⚠ P/N:544-3755

DESCRIPTION		D-SUB WITH 9-PIN FEMALE CONNECTOR BY MACHINING							
製圖	DRAWN	TOLERANCE		品名	050-0009S-M	日期	DATE	版次	REV.
	Yoko	.X	±0.2	TITLE	\ROHS COMPLIANT	03.06.08			A-4
檢圖	CHECK	.XX	±0.1	單位	mm(in)	DWG.NO. 55-0045			
	Ivan	.XXX	±0.05	SCALE					
認定	APPROVAL	ANGLE	±5°	比例	2:1				
	Angela

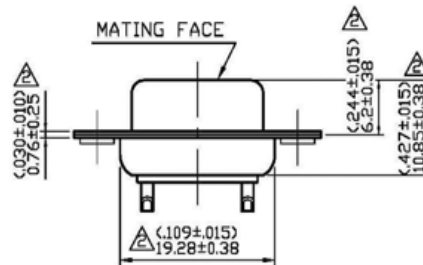
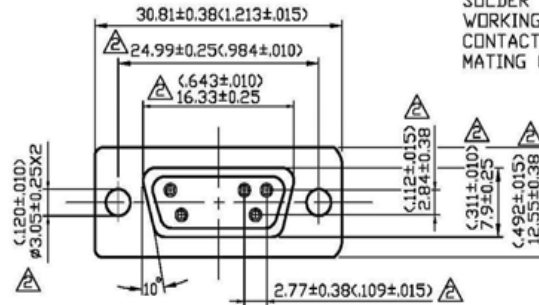
NO	DESCRIPTION	DATE
⚠	ADD MIS PART NO.	04.01.04
⚠	ADD DESCRIPTION ADD 6.2±0.38 24.99±0.13 → 24.99±0.25 16.33±0.13 → 16.33±0.25 ø3.05 → ø3.05±0.25 7.9 → 7.9±0.25 12.55 REF. → 12.55±0.38 2.77 → 2.77±0.38 19.28 REF. → 19.28±0.38 1 → 0.76±0.25 10.72 REF. → 10.72±0.38 11 REF. → 10.85±0.38 3.3 REF. → 2.4±0.5 2.84 → 2.84±0.38 TIN → GOLD MIS PART NO. → P/N	10.02.07
⚠	CORRECT DIMENSION LINE POSITION	12.02.11
⚠	GOLD	05.16.13
